**Meeting Date:** Tuesday 21 February 2012  
**Location:** Committee Room 2, Level 5, Civic Centre, 1 Devlin Street, Ryde  
**Time:** 4.00pm

**NOTICE OF BUSINESS**

<b>Item</b>	<b>Page</b>
1 CONFIRMATION OF MINUTES - Meeting held on 7 February 2012.....	2
2 7 DAYMAN PLACE, MARSFIELD. LOT 3 DP623320. Local Development Application for demolition of existing dwelling and erection of a new 3 storey boarding house containing 77 boarding rooms, 1 manager's residence and communal facilities. LDA2011/375. <i>INSPECTION 4.20PM / INTERVIEW 4.50PM</i> .....	24
3 35 BUENA VISTA AVENUE, DENISTONE. LOT 79 DP 16433. Local Development Application for Alterations and additions to dwelling including new inground swimming pool. LDA2011/0337. <i>INSPECTION 4.35PM / INTERVIEW 5.00PM</i> .....	88

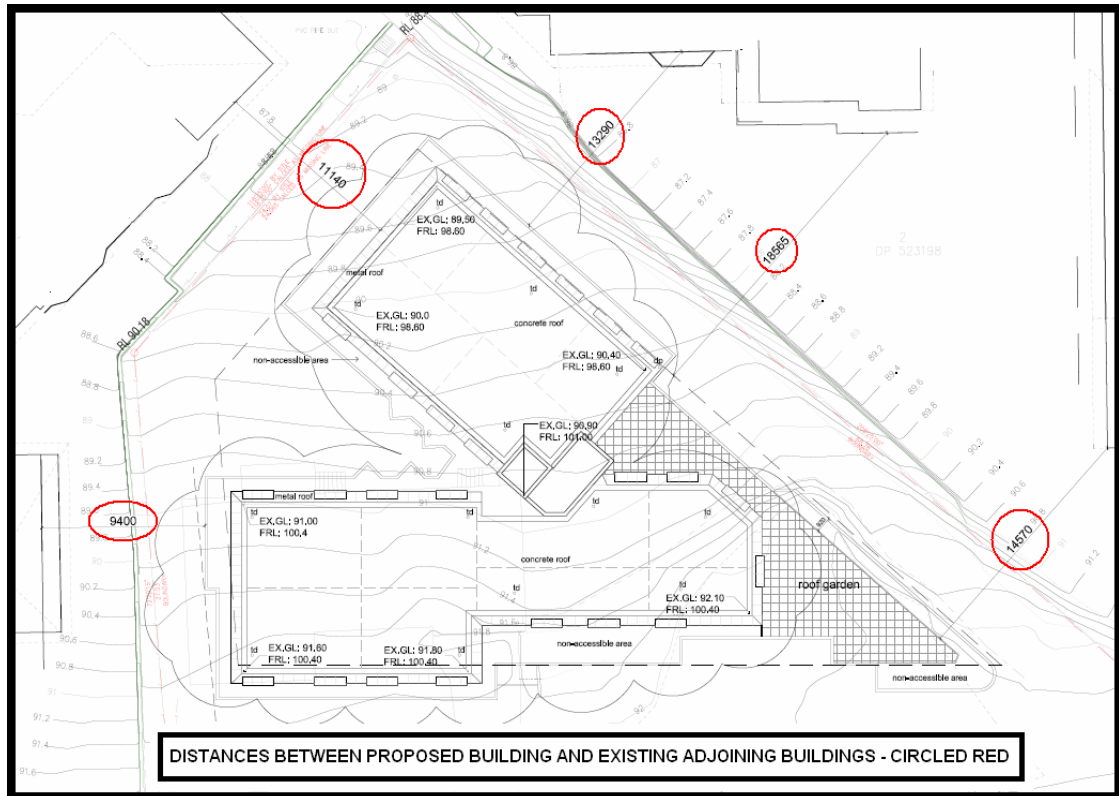
The applicant has also provided a plan showing the distances between the proposed and adjoining buildings (see below). This shows that these distances range from 9.4m to 11.14m to the adjoining residential flat building. It is noted that these distances are less than the 12m identified in the submission (based on planning publications such as AMCORD – Australian Model Code for Residential Development), however the existing setback of the adjoining residential flats (4.7m – 5.5m) also contributes to small separation distances due to its existing setback.

Overall, the provision of privacy screens to the direct-facing windows, the relocation of other windows which previously faced the adjoining properties, and the fencing to the outdoor communal space has satisfactorily resolved the issue of privacy both to and from the adjoining development to the north, having regard to the distance separation and nature of the development on both sites.

## 2. Height:

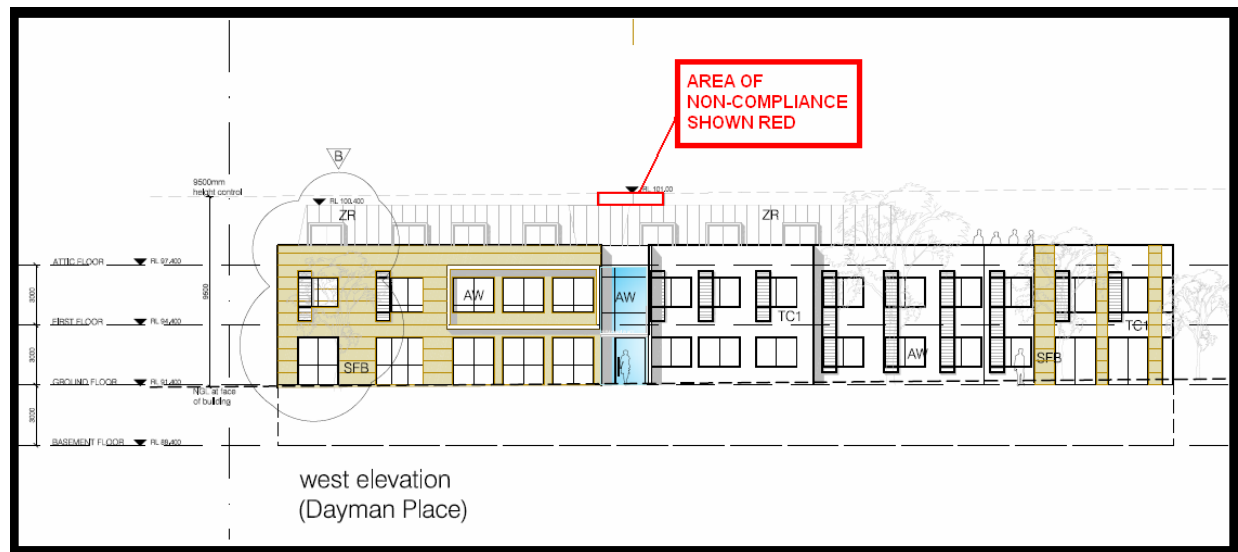
DCP 2010 Part 3.4 contains a height requirement measured both in metres (maximum 9.5m in "Area J" under Ryde LEP 2010 which includes this site), and storeys (maximum 2 storeys in "Area 2" under Ryde DCP 2010 which includes this site).

The proposed development has a height ranging from 8.2m to 9.4m (except lift over-run which is 10.1m at that point of the development). The number of storeys is noted by the applicant as being 2 storeys plus attic, however the "attic" is considered to be a storey in its own right and therefore the development has 3 storeys, which does not comply.

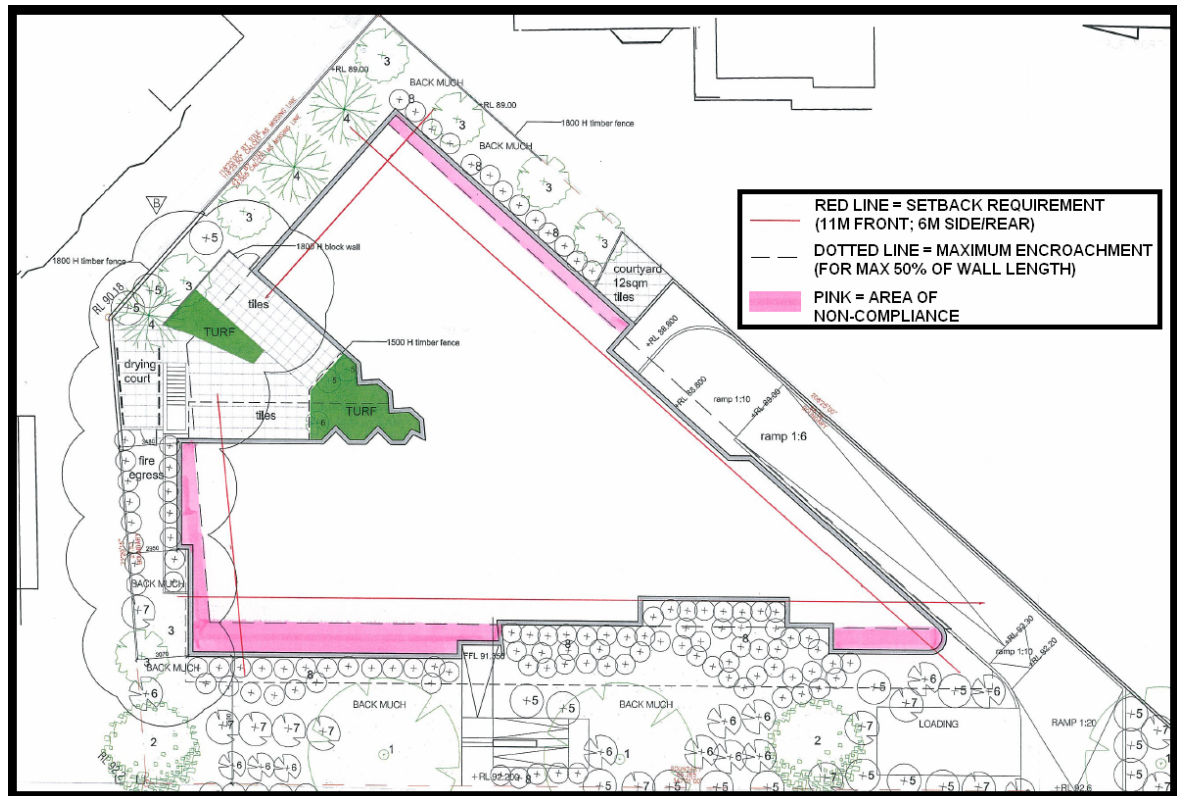
Rear setback (to south-eastern boundary) proposed = 3.5m to 4.6m (1000mm to basement, not including ramp to basement) (does not comply).

The following drawing shows (in pink) the portions of the building which encroach within the minimum permitted front and side/rear setbacks. It is noted that other parts of the building also do not comply with the “maximum 50%” encroachment rule as specified above:

**Front Elevation (original proposal)**

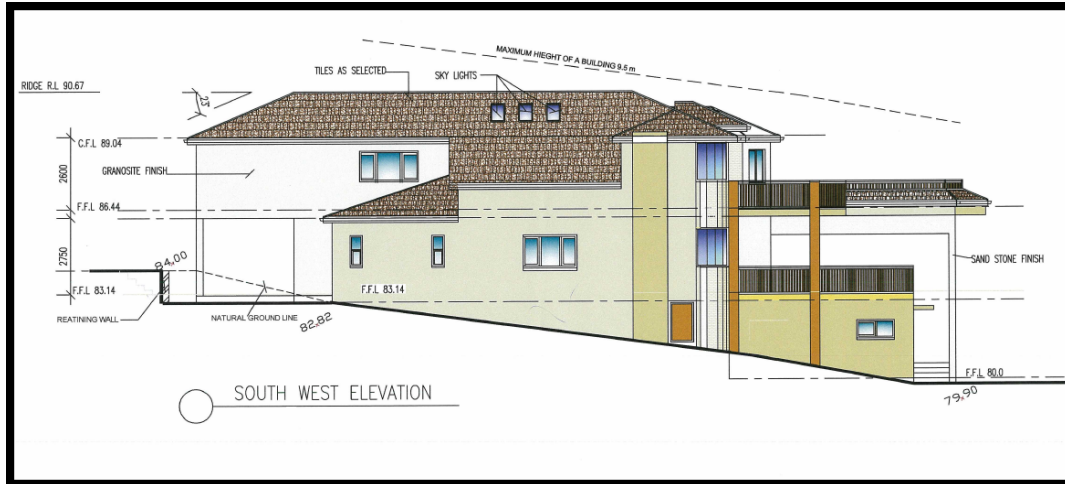
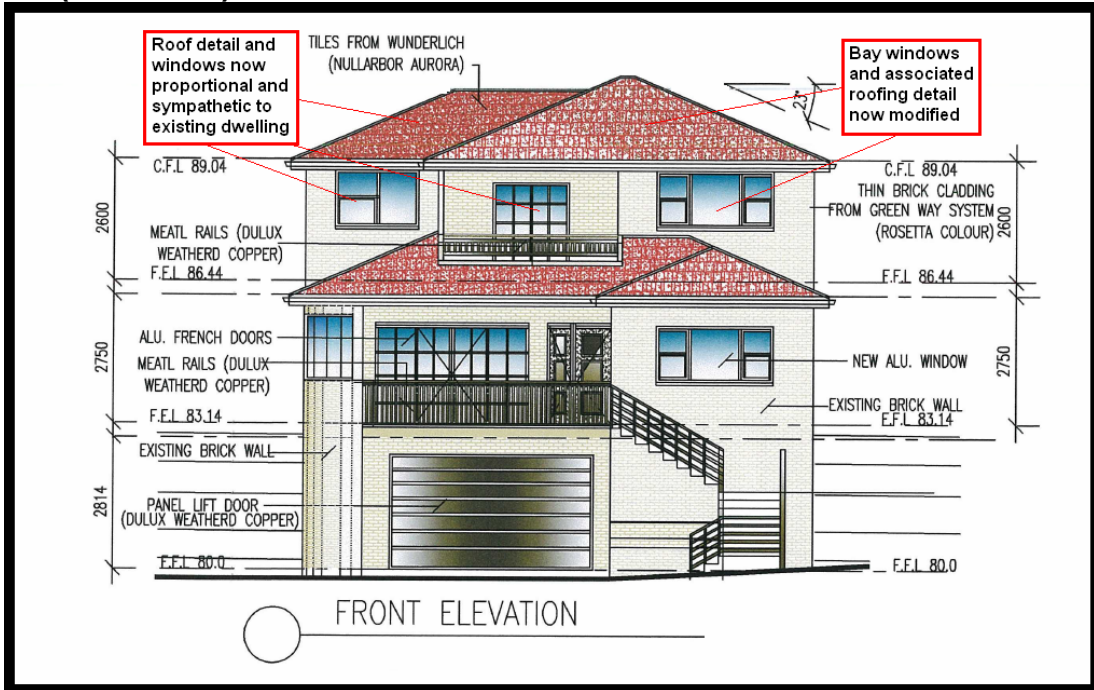
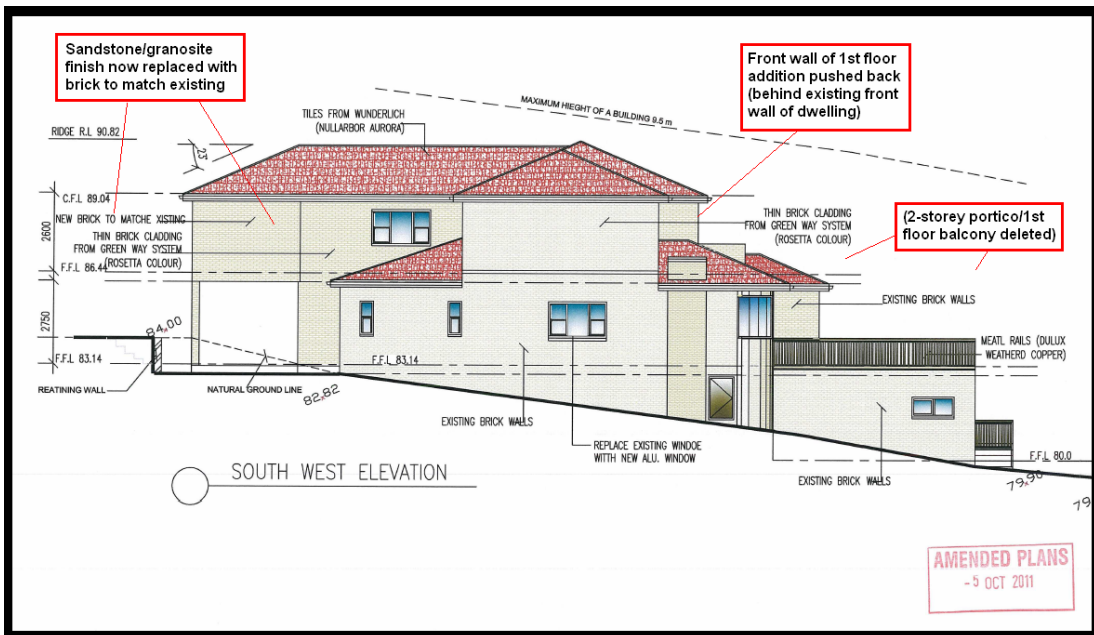
Below are the front elevation and side (south-west) elevation drawings of the original proposal:

The applicant submitted amended plans on 5 October 2011 which include the following amendments:

1. **Denistone Character Area.** *The proposal is inconsistent with the controls for the Denistone Character Area – in particular the 2-storey portico/balcony, the use of sandstone and aluminium windows as external finishes, and the projection of the front façade forward of neighbouring properties are all considered to be design features that are inconsistent with the Denistone Character Area. One of the requirements of the Denistone Character Area controls is "to ensure new development is compatible with the positive characteristics of the existing streetscape", and "large block-like forms are not acceptable".*

Comment: Agreed. The proposal as originally submitted was considered to be inconsistent with the Denistone Character Area controls, and was not supported by Council's Assessment and Heritage Officers. The amended plans have satisfactorily addressed the concerns previously raised regarding consistency with the Denistone Character Area.

**(b) Topography and excavation:**

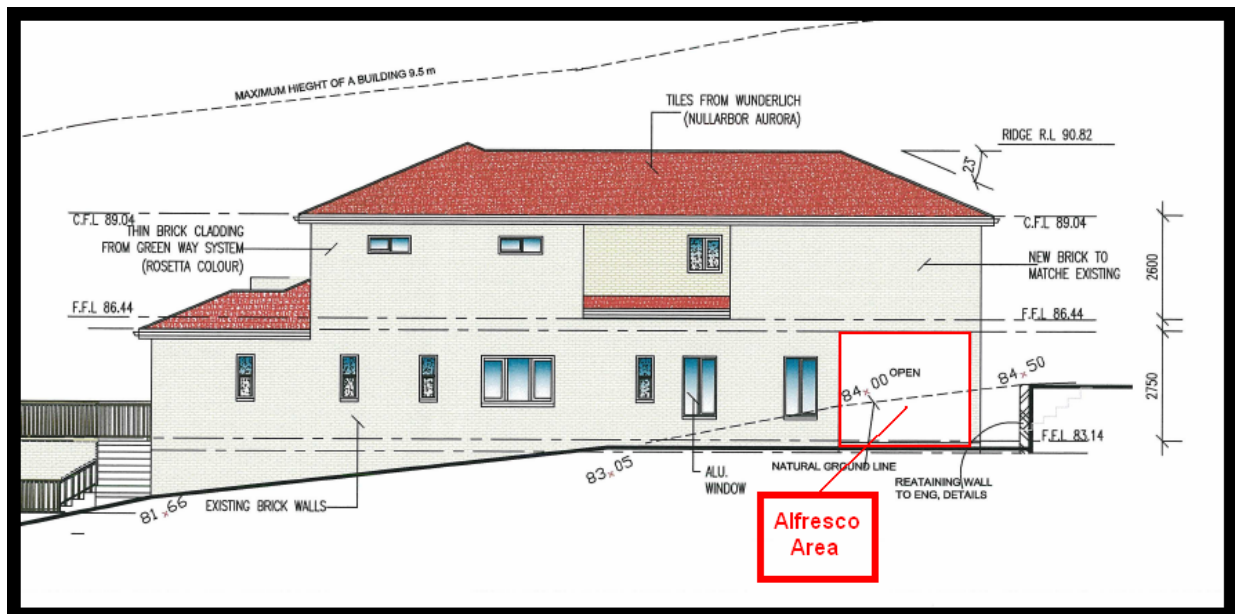
DCP 2010 contains maximum requirements for excavation – generally a maximum of 1.2m of cut within the building footprint, and maximum 900mm excavation outside the building footprint, and a maximum retaining wall height of

900mm. This development does not comply with these requirements, as it involves an alfresco area at the rear which is to be some 1.36m below natural ground level.

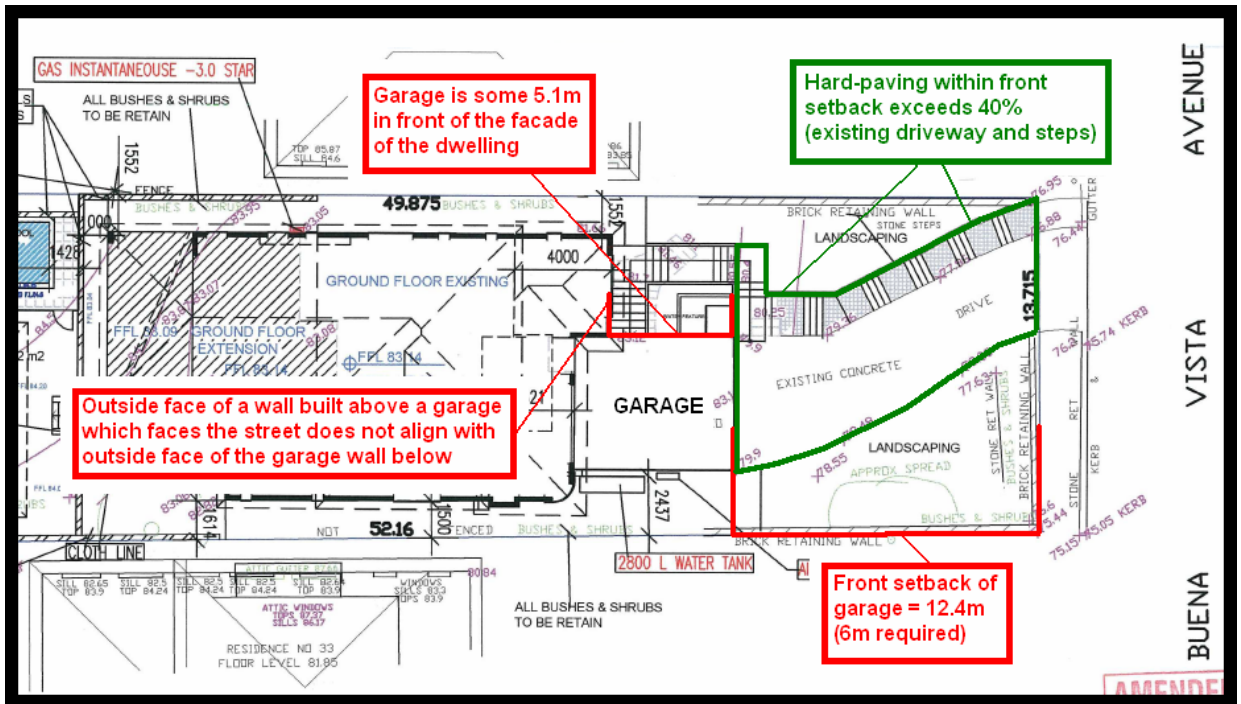
As noted in (c) above, this is a technical non-compliance caused by the existing garage. Given that this is an existing situation, no objections are raised despite the non-compliance with the DCP.

The actual front setback of this development (12.4m to garage) fully complies with the minimum setback in the DCP (generally 6m).
